Response to Referee #1 of our manuscript entitled Coastal Impacts of Storm Gloria (January 2020) over the Northwestern Mediterranean [nhess-2020-75] submitted to Natural Hazards and Earth System Sciences.

Angel Amores, Marta Marcos, Diego S. Carrió, and Lluís Gómez-Pujol

May 21, 2020

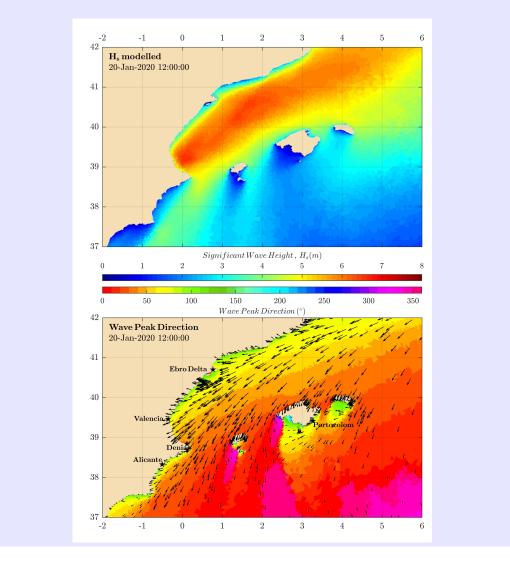
1) The authors should try to expand on the analysis of the spatially varying wave contributions to the total surge, specifically on why there are two hotspots (Ebro Delta and Denia in Figure 6b) along the coast. In Section 3 (Ln 194), Ebro Delta and Denia are found to differ from other along-shore regions in wave contribution (> 20 cm, compared to mostly < 7 cm elsewhere; 40-50% of the total surge, compared to mostly ;10% elsewhere, as estimated from Figure 6b). Is this pattern related to shoreline geometry, topography/bathymetry, or forcing? Does mesh resolution have anything to do with it (seems not, since Denia is not refined)? Please elaborate either before or within Section 3.1; a short paragraph or 2-4 sentences will do.

Author's response: To illustrate our response we have produced the Figure below, that maps significant wave height (H_s , top panel) and wave peak direction (D_p , bottom panel) at the time that Storm Gloria hit stronger along the coast of the mainland (January 20^{th} , 2020). As the reviewer states the maxima wind-wave contributions to the total surge in Denia and the Northern side of the Ebro Delta is a physical effect linked to the wave direction. It is not related to the grid resolution since, as the reviewer noted, the area around Denia is not refined. These two spots were the areas where the waves hit the coast more perpendicularly and, consequently, the wave setup was larger. We thus conclude that the observed pattern in these two spots is a combination of the forcing (with large H_s and that direction) and the shoreline geometry, coinciding with the direction perpendicular to the forcing. We have added a paragraph explaining this fact just before section 3.1, following reviewer's advice.
